RTCA Special Committee 209

Mode S Transponder MOPS Maintenance

Meeting #3

**Detailing The Proposed Changes to Figures in
Order to Harmonize DO-181D and ED-73C**

Figure 2-11: ORIGINAL FROM DO-181D, v1.1

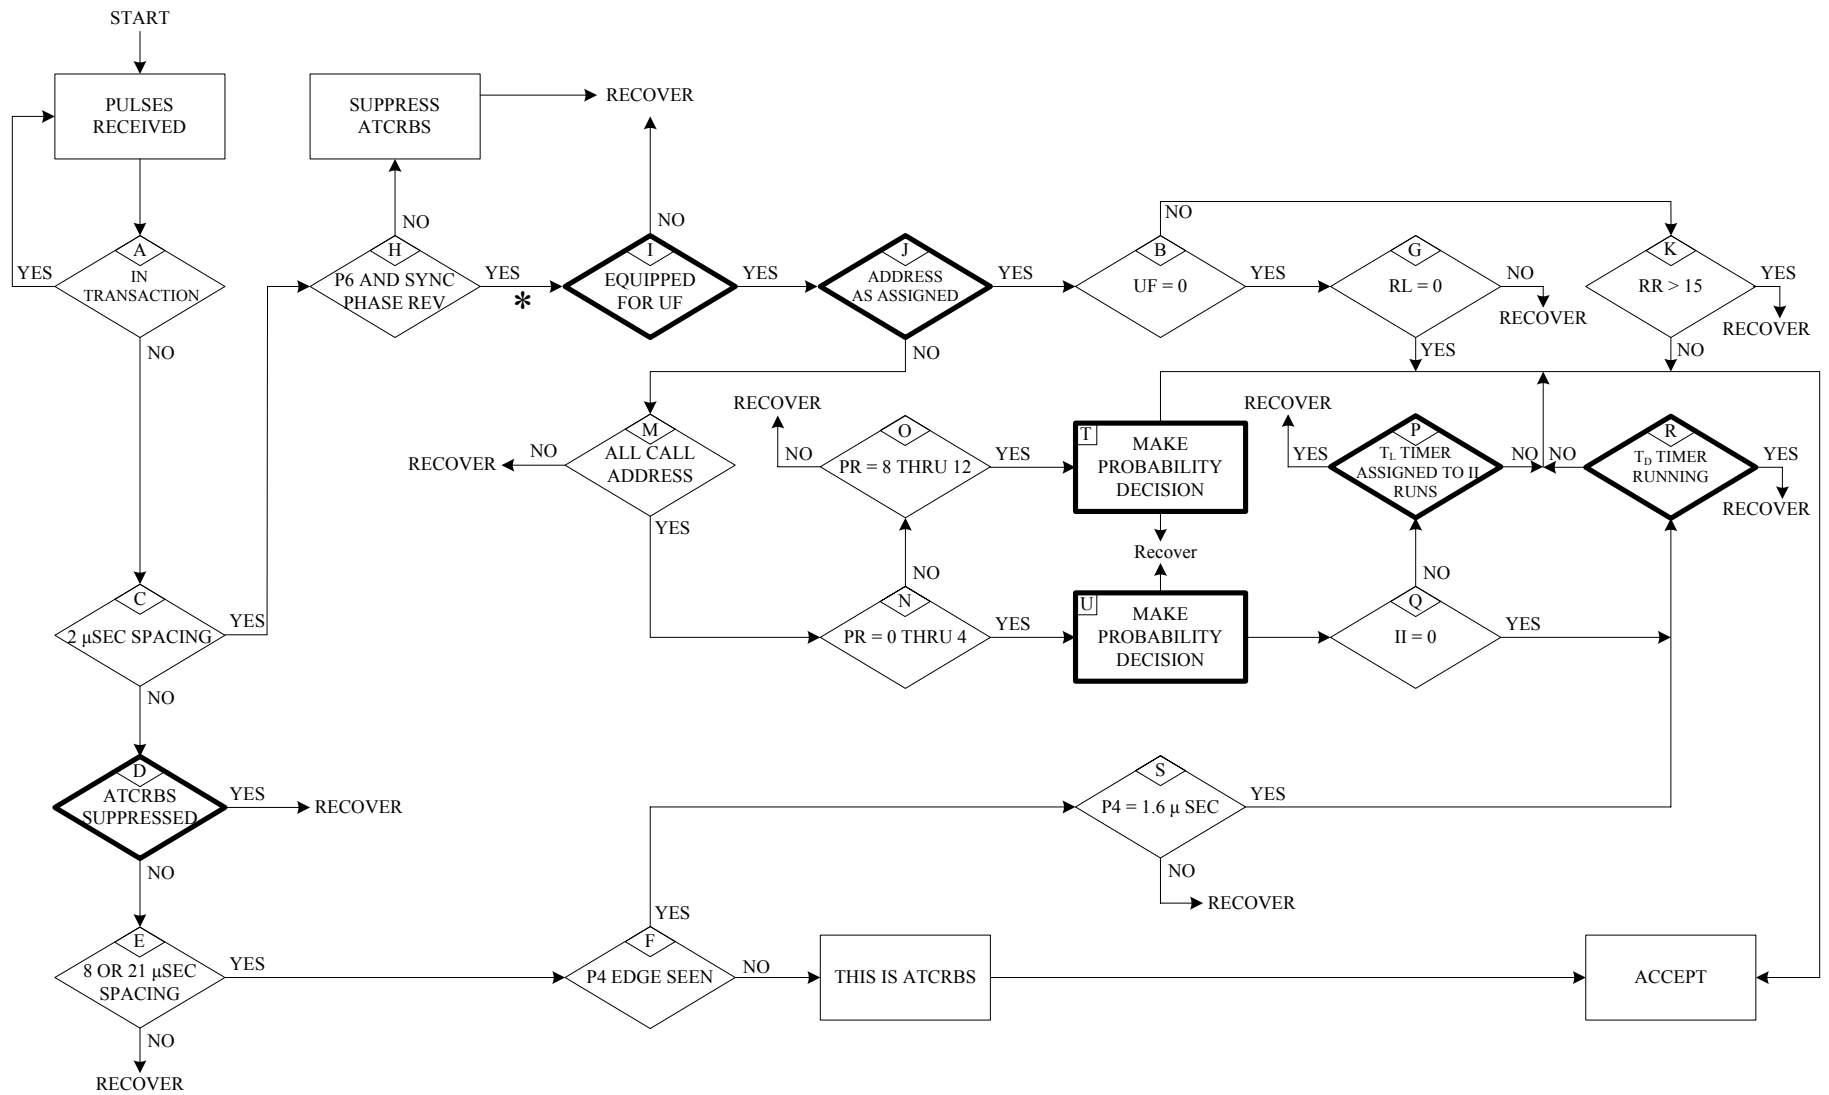
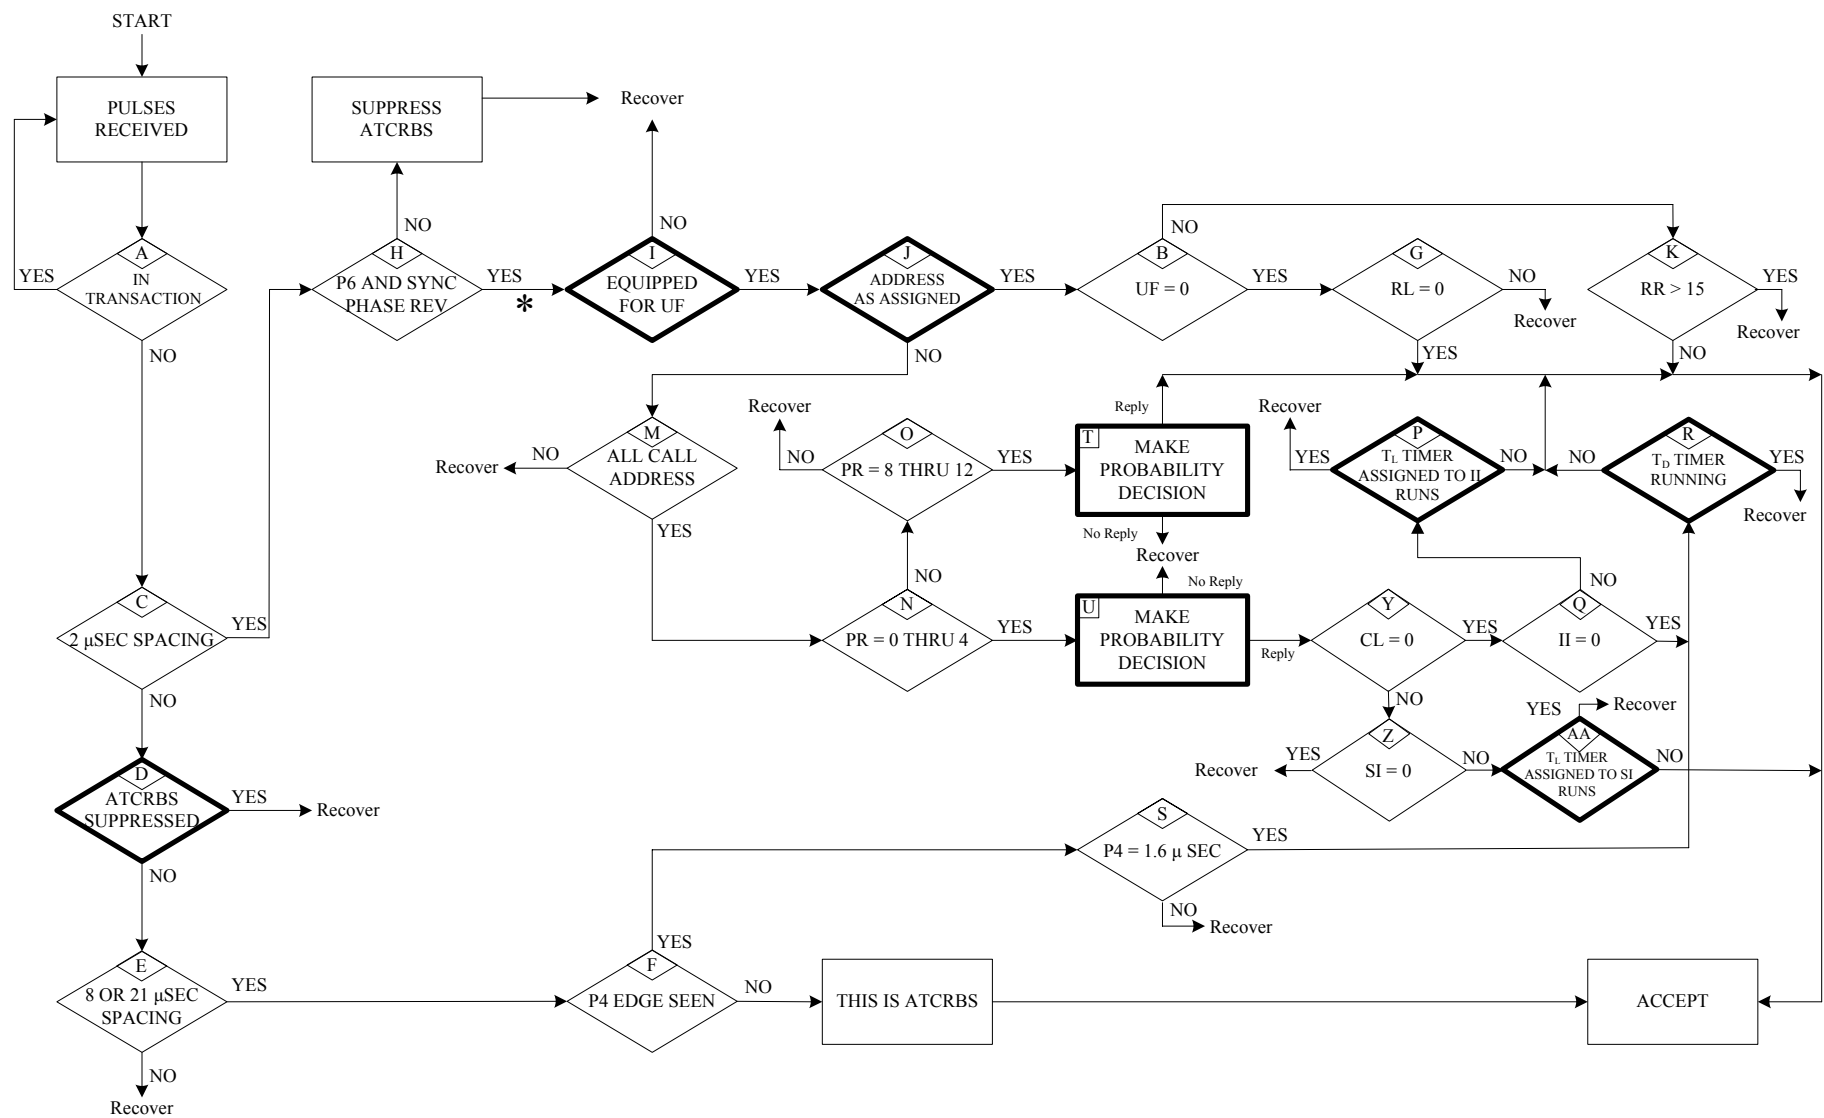
1. Figure 3-3 in ED-73C needs to be updated by revising UF=19 as agreed to during Brussels meeting.
2. Figure 3-4 in ED-73C needs to be updated by revising DF=19 as agreed to during Brussels meeting.
3. Figures 3-5A and 3-5B in ED-73C for Uplink and Downlink Fields need to be updating by adding AF, CF, II and SI, as appropriate.
4. Figure 2-11 in DO-181D differed from Figure 3-10 in ED-73C because it appears that Figure 3-10 had been updated to add the decision boxes for SI protocol and Figure 2-11 had not been updated. Therefore Figure 2-11 is shown below as the original and Figure 2-11R1 is shown as modified to account for the addition of the blocks for SI protocol.

Figure 2-12(A)R1: WITH CHANGES PROPOSED TO HARMONIZE WITH ED-73C Figure 3-11 for SIS=0

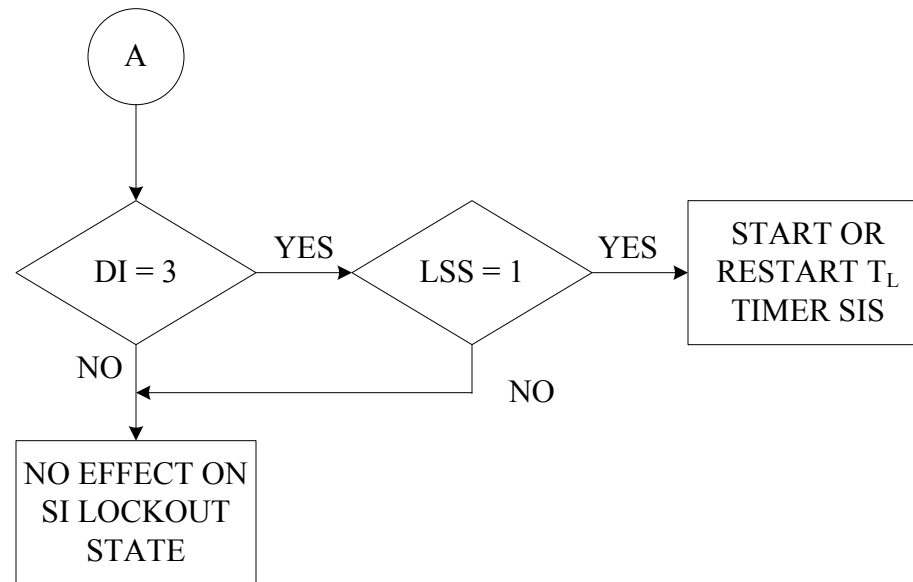
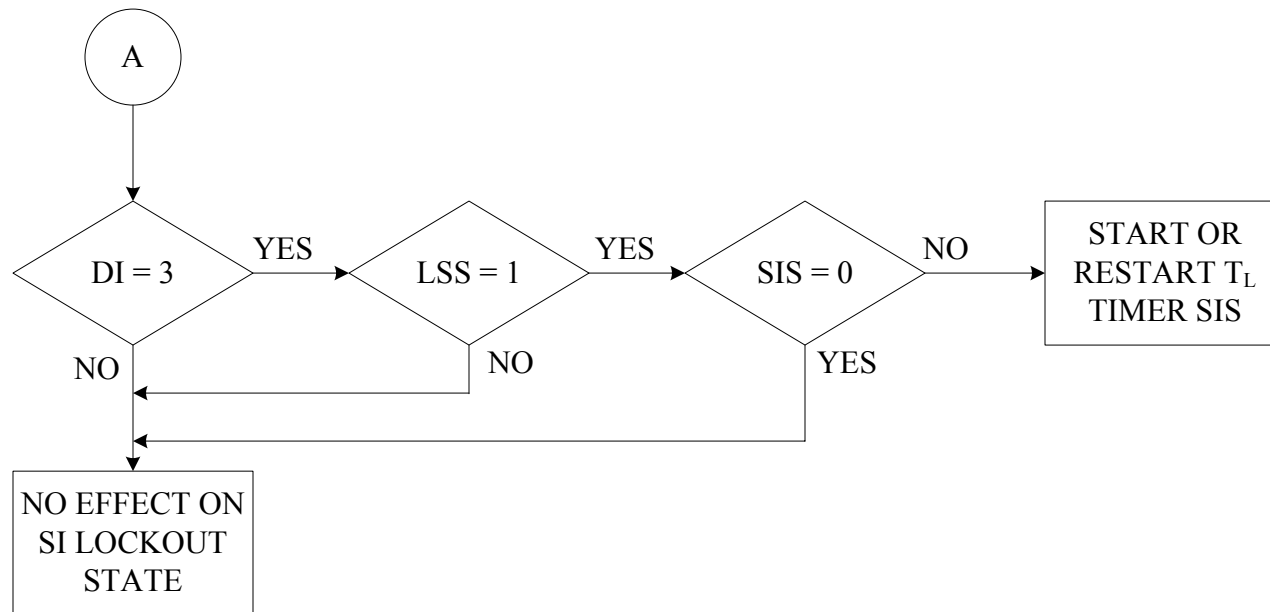
5. Figure 2-12(A) in DO-181D differed from Figure 3-11 in ED-73C because it appears that Figure 3-11 had a decision box for SIS=0 and Figure 2-12(A) had not been updated. Therefore Figure 2-12(A) is shown below as the original, and Figure 2-12(A)R1 is shown as modified to account for the addition of the blocks for SIS=0.

Figure 2-14R1: WITH CHANGES PROPOSED TO HARMONIZE WITH ED-73C Figure 3-13

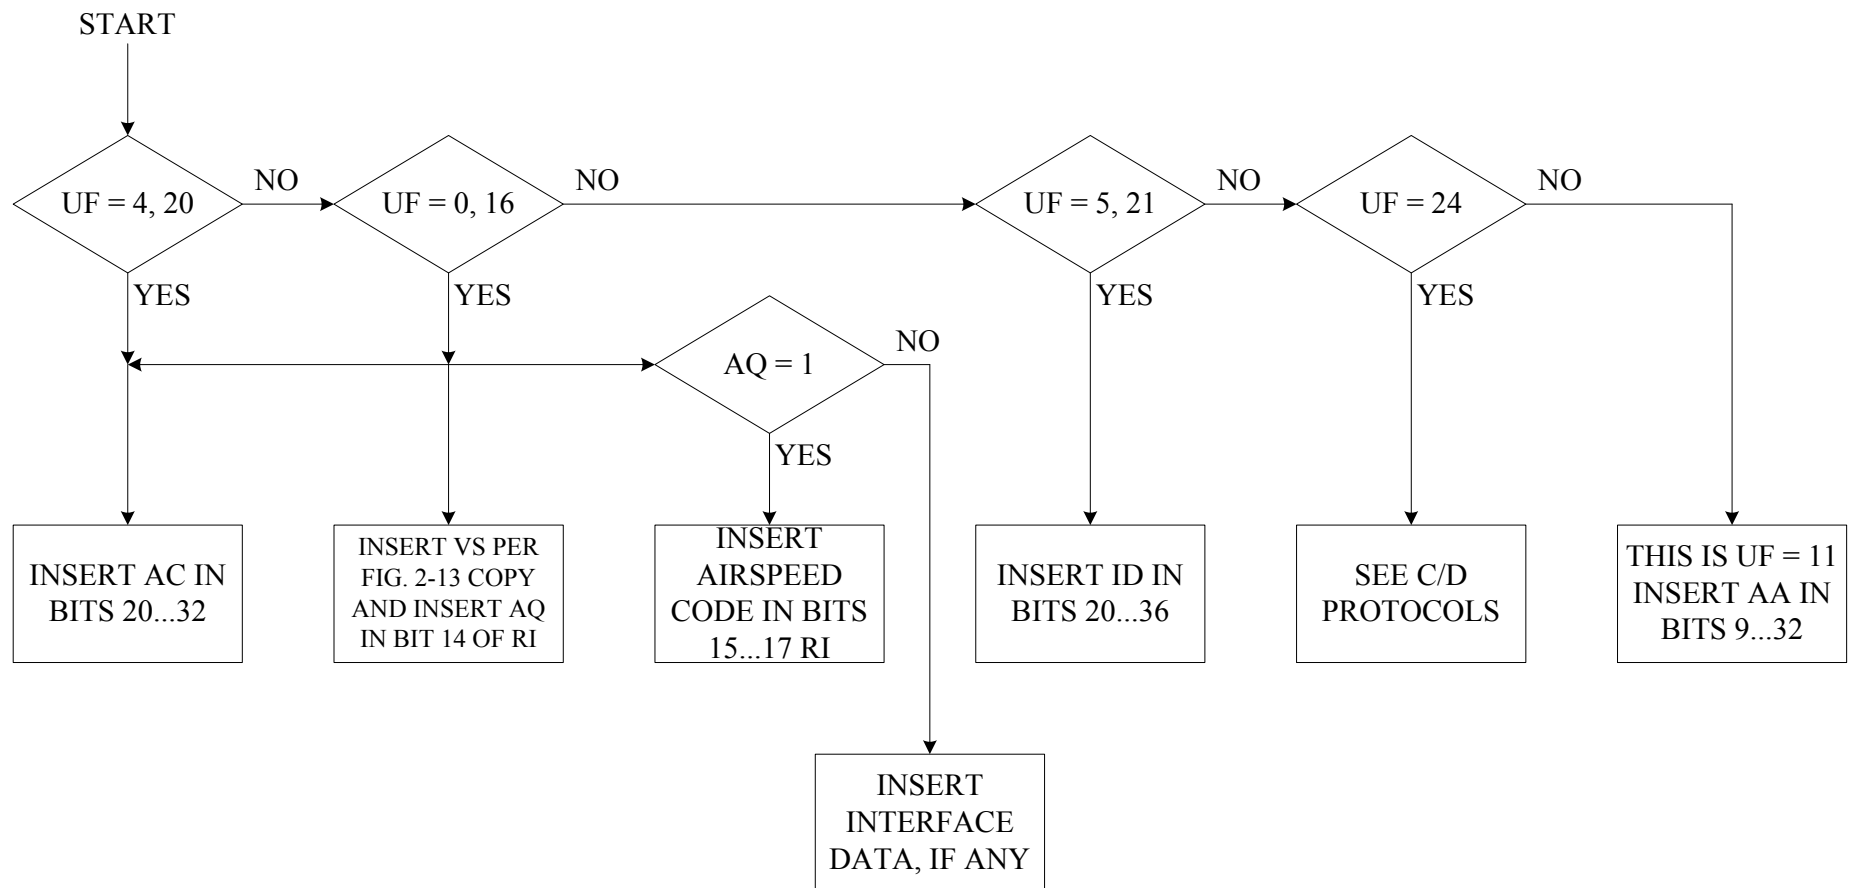
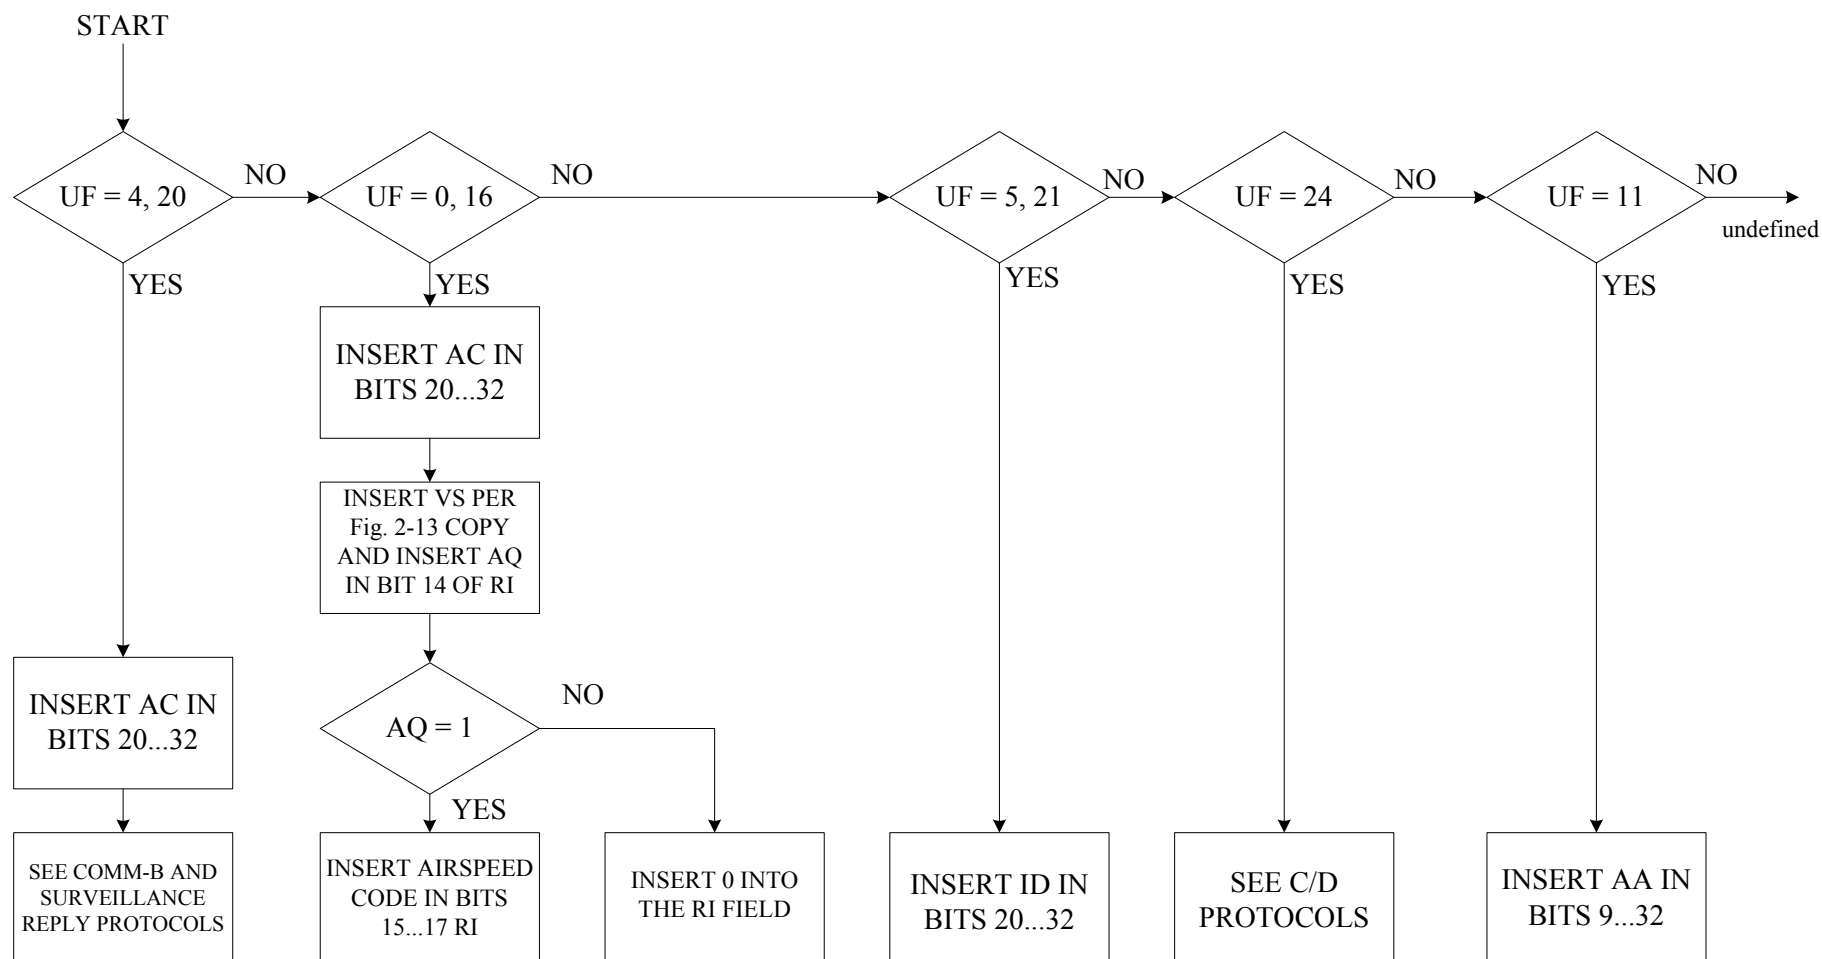
6. Figure 3-12 in ED-73C is missing a “YES” decision on the right side of the figure coming out of the “A” box.
7. After analysis it appears that Figure 2-14 in DO-181D has several errors and that Figure 3-13 in ED-73C is correct. Therefore, Figure 2-14R1 is proposed to be updated to match Figure 3-13 as shown below.
